Rezoning Transportation Analysis

Petition Number: 2018-090

Date	Description
08-15-18	First Review

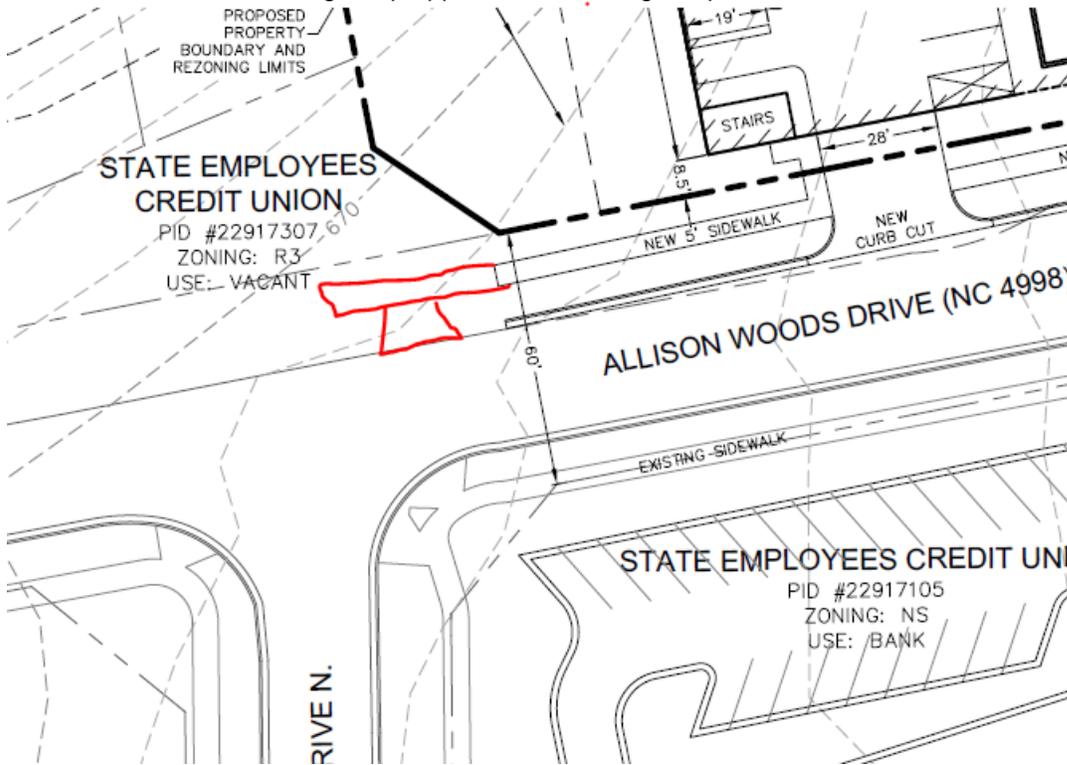
1. **Curbline** The proposed zoning district has a setback measured from back of the existing or proposed future curbline. The location of the future back of curb is in its current location.
2. **Traffic Study** A Traffic Impact Study/Transportation Technical Memorandum is not necessary for the complete review of this petition.

- The petitioner should revise the site plan and conditional note(s) to extend sidewalk on Allison Woods Drive and create a receiving ramp opposite the existing ramp on other side of road.

- The petitioner should revise the site plan to add a note specifying dedication and fee simple conveyance of all rights of way to the City before the site's first building certificate of occupancy is issued. CDOT requests right of way set at 2' behind back of sidewalk where feasible.
- The petitioner should revise the site plan to add a note specifying all transportation improvements will be approved and constructed before the site's first building certificate of occupancy is issued. The petitioner may phase transportation improvements if said improvements and phasing are explicitly described in site plan notes.
- ~~Resolved~~ Sample format for comment that is resolved
